Re: 708 E. 12th Street – Downtown Density Bonus Program (“DDBP”) Application and Summary of Compliance with the City of Austin’s Urban Design Guidelines for a hotel tower project located at 708 E. 12th Street and 1200 N IH-35 Service Road related to site development permit application case SP-2022-0543C.

Date: June 12, 2023  
To: City of Austin Design Commission  
From: Planning & Urban Design Working Group  
Subject: Density Bonus Working Group review of 708 E 12<sup>th</sup> Street substantial compliance with the Urban Design Guidelines  
Meeting date: June 7, 2023; 12:00 pm; Virtual Microsoft Teams Meeting  
Applicant: Leah M. Bojo

## **WORKING GROUP REVIEW OF PROJECT FOR COMPLIANCE WITH THE URBAN DESIGN GUIDELINES**

BUILDING ELEVATIONS -  
WEST & NORTH

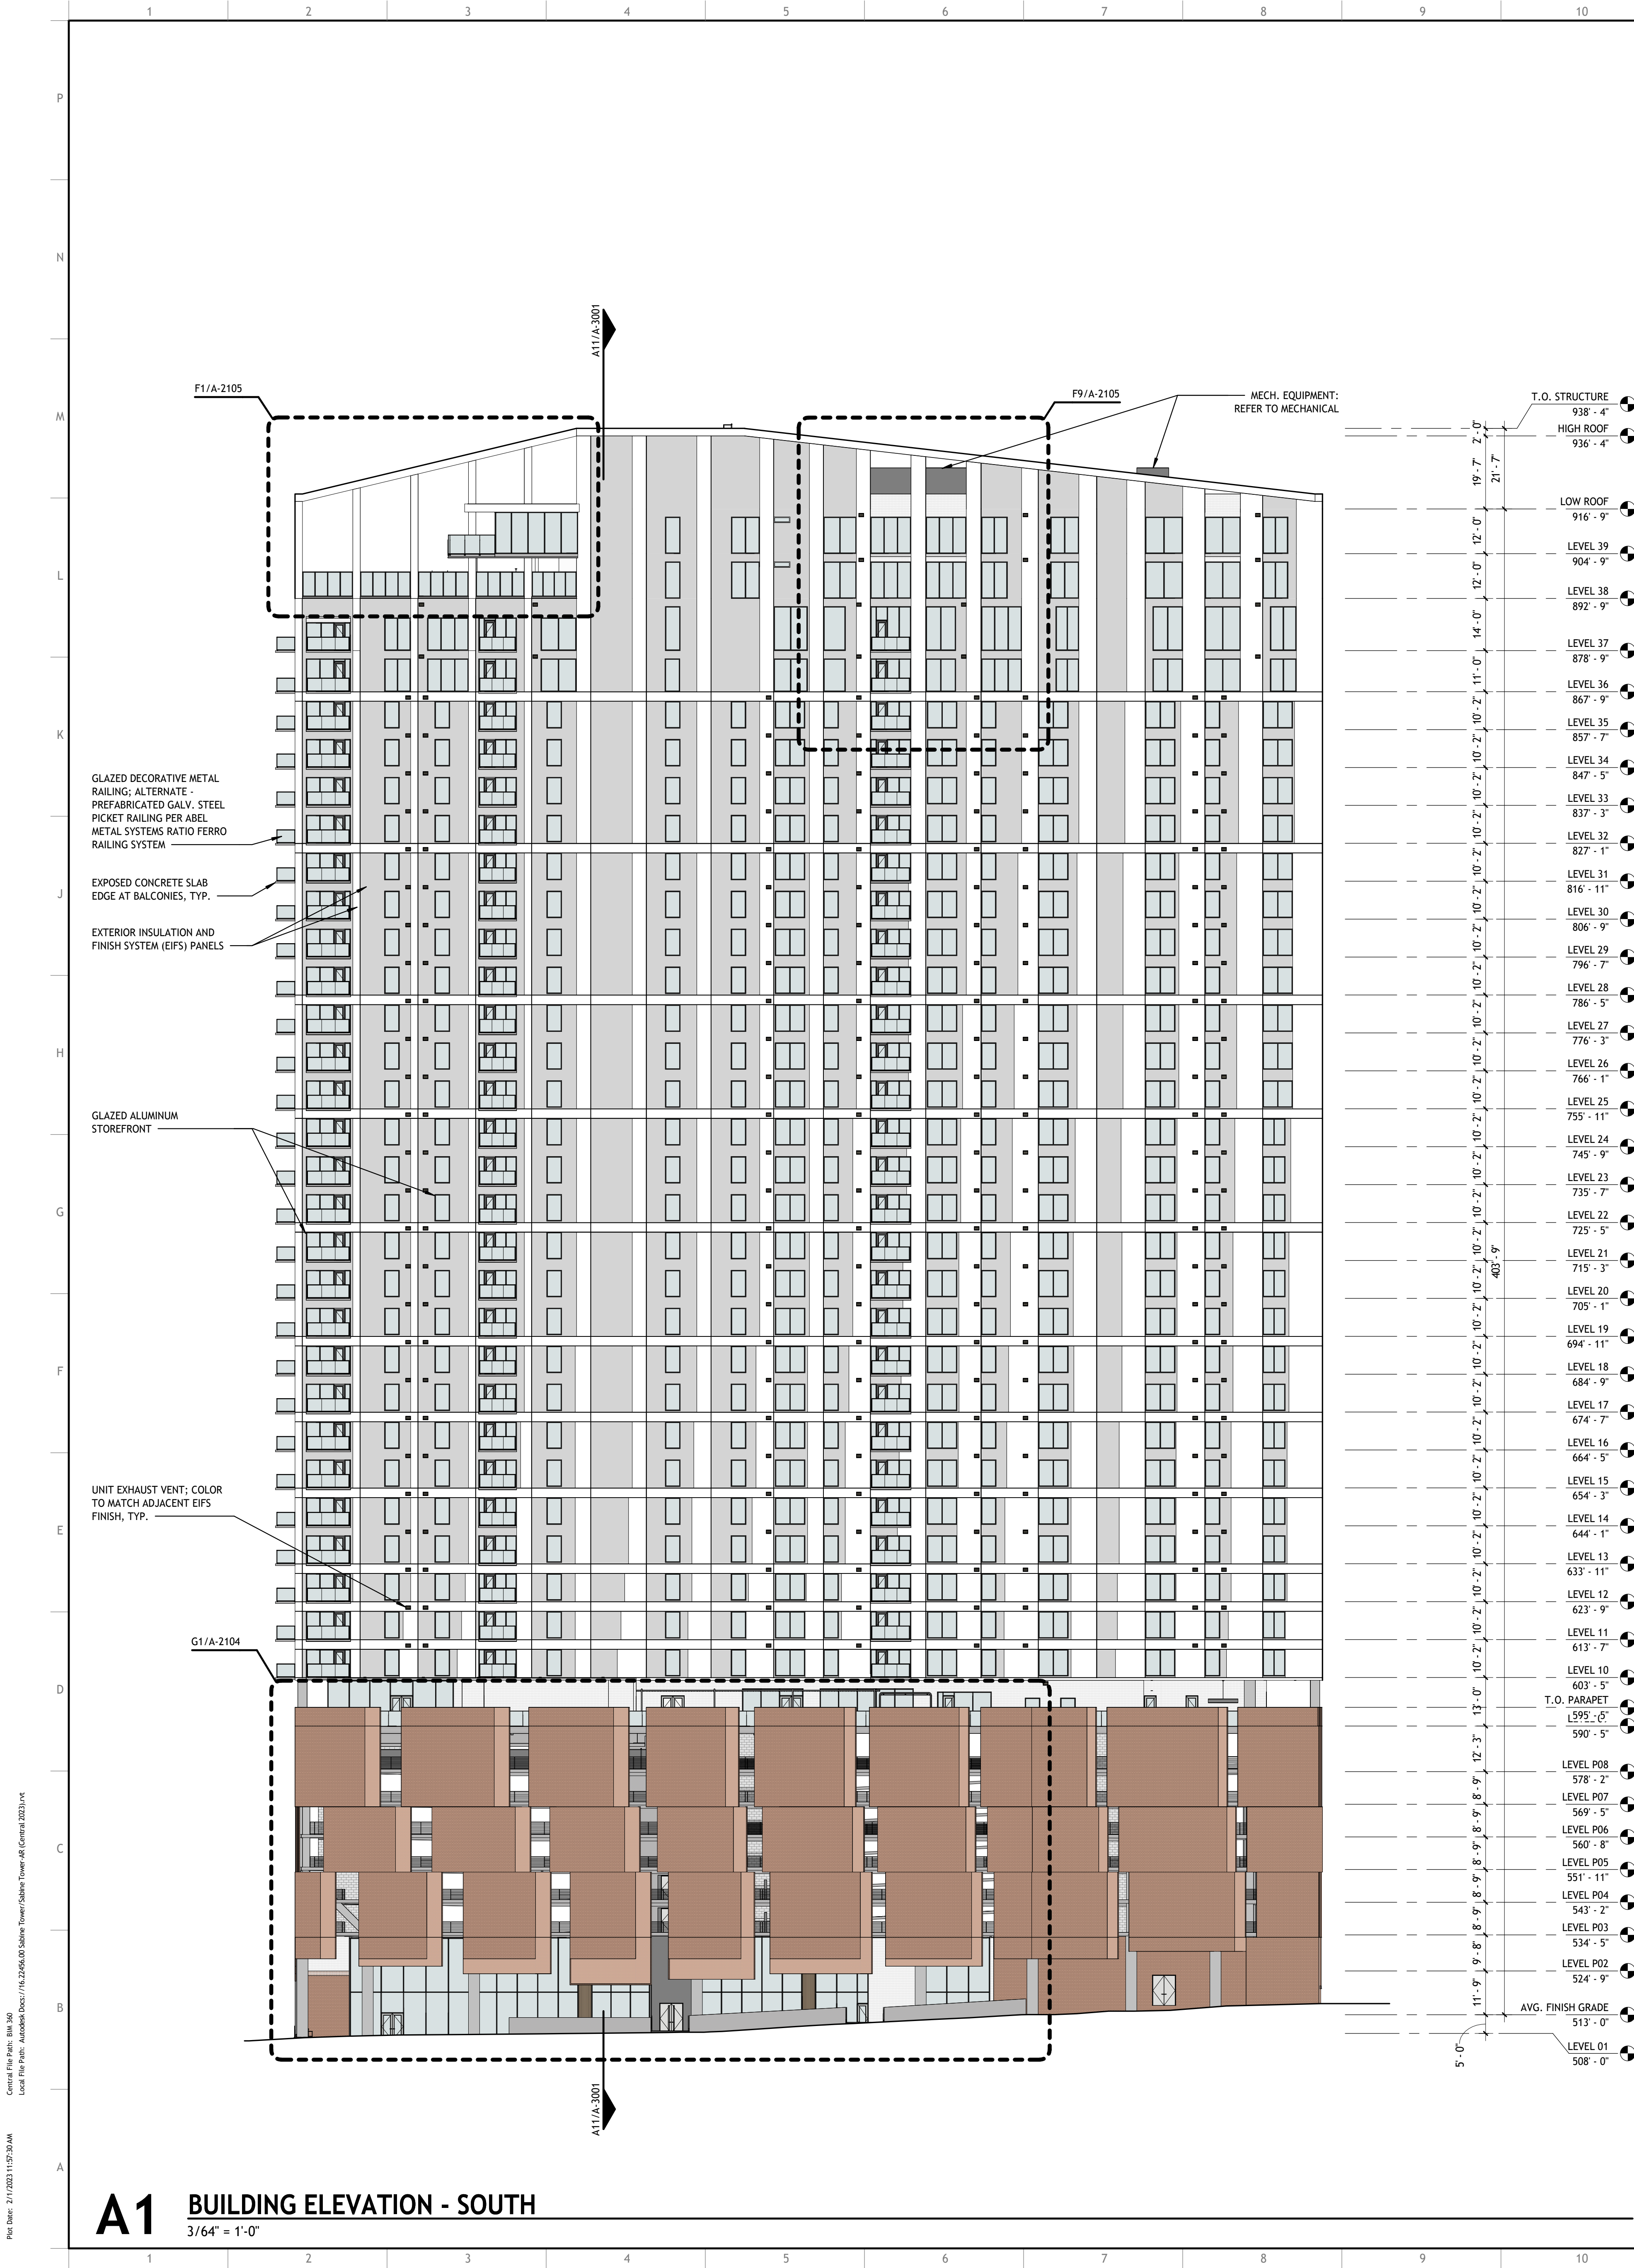
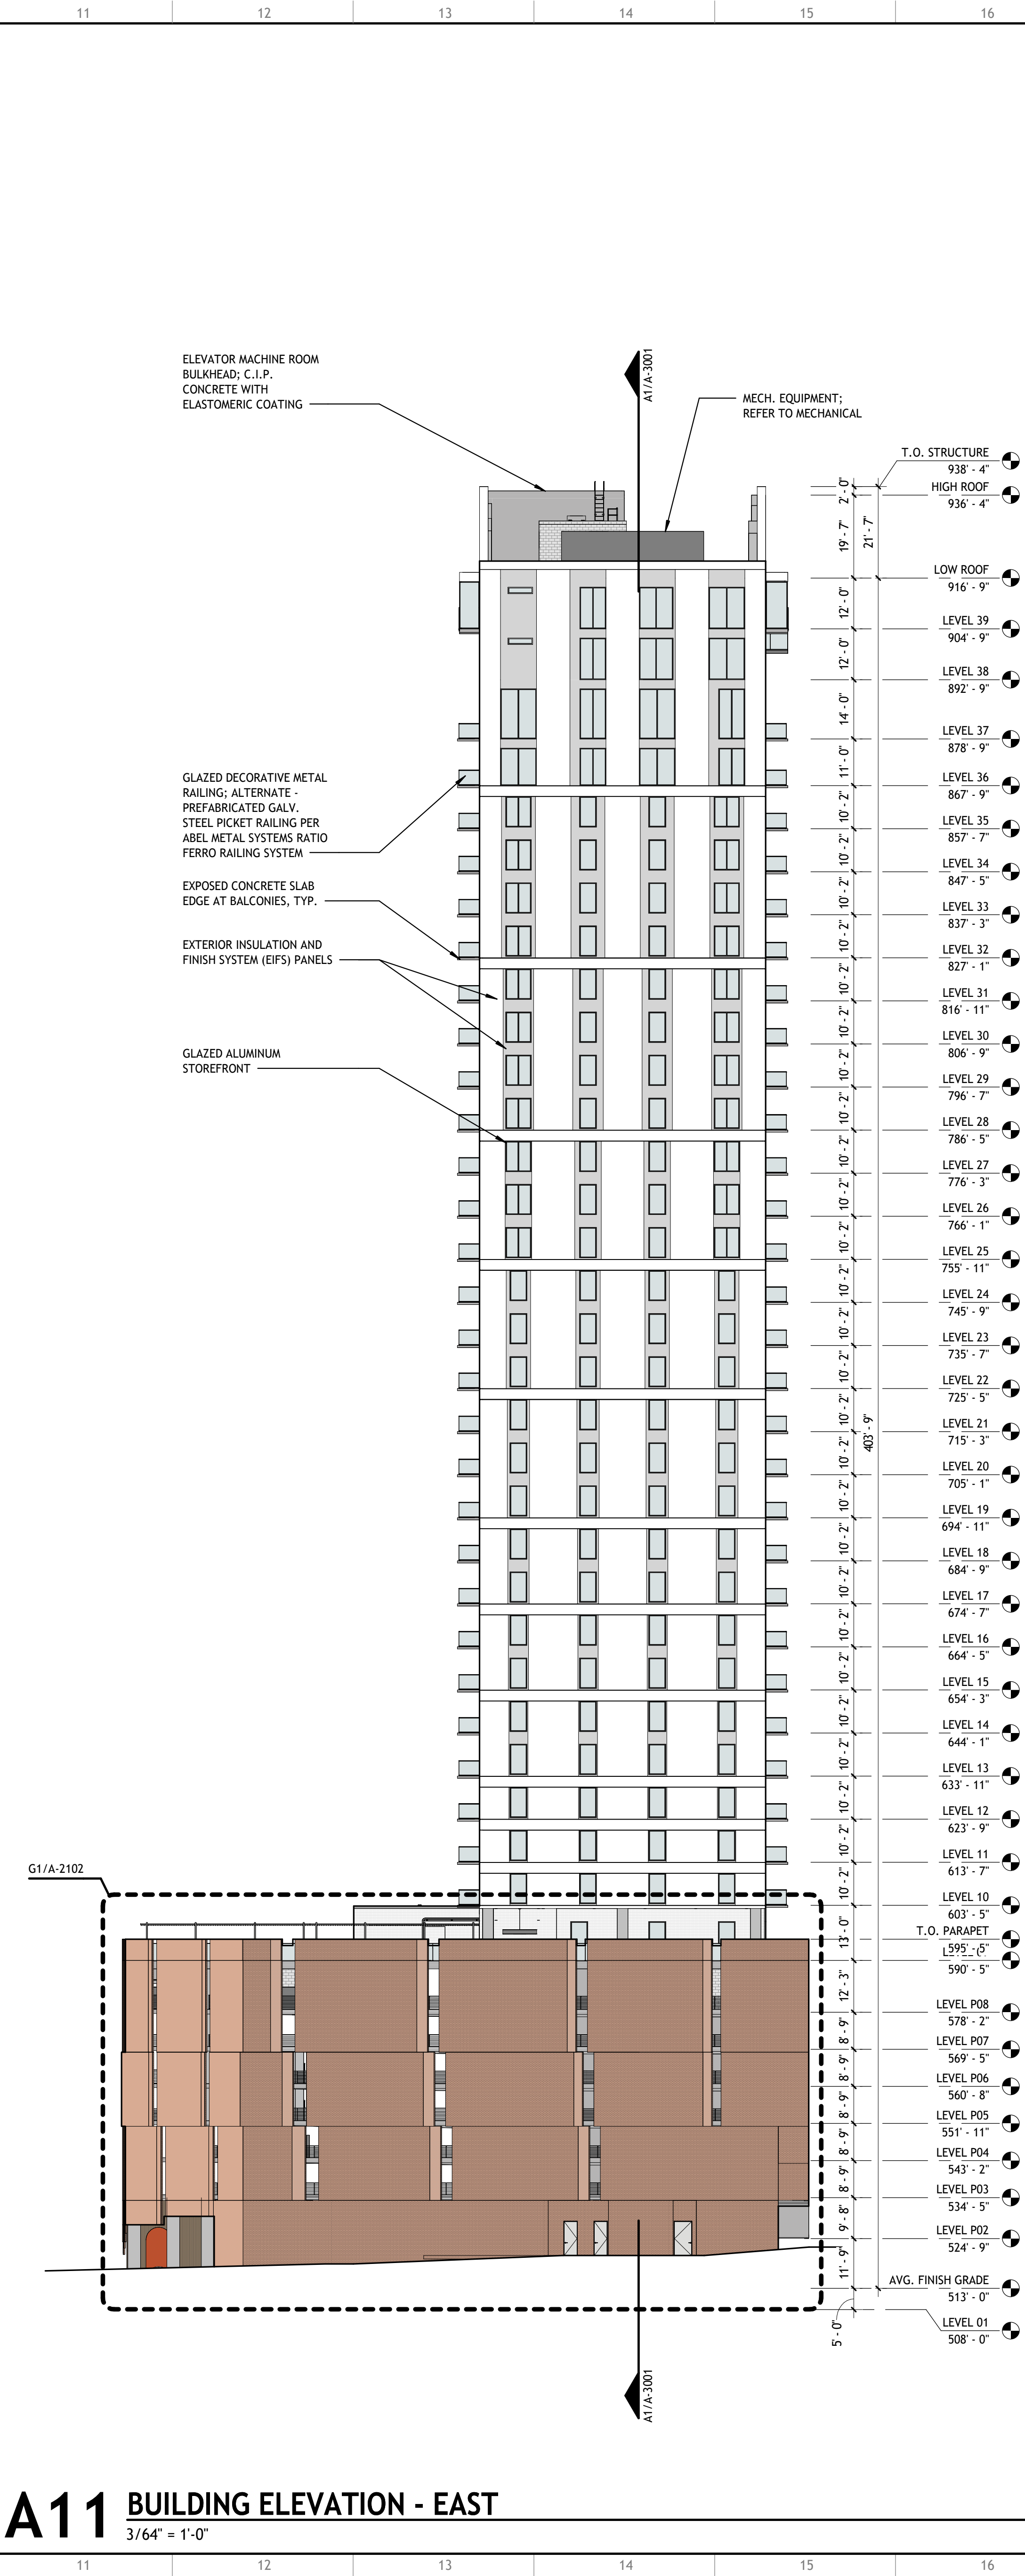
4. Buffer neighborhood edges-  
N/A
5. Incorporate civic art in both public and private development –  
Project is not currently incorporating any public art. Project does **not** comply with this Section.  
*Working Group Thoughts:*

- utilizing art on the north & east elevations to shield parking structures
  - Incorporate Red River Cultural District tie-ins with opportunities for live music performance, pre-wired staging areas, etc

11. Screen mechanical and utility equipment-  
project does **not** comply with this section.  
*Working Group Thoughts:*
  - Mechanical and utility equipment are visible from I-35.

- East and North sides of building need further refinement as it relates to views from S I-35 and Frontage rd. S I-35 Frontage does have a sidewalk and East façade should provide more friendly façade to potential pedestrians.

- Project more human scale facades on North and East sides of buildings. Even though they face the substation and S I-35 they will be viewed by many humans each day
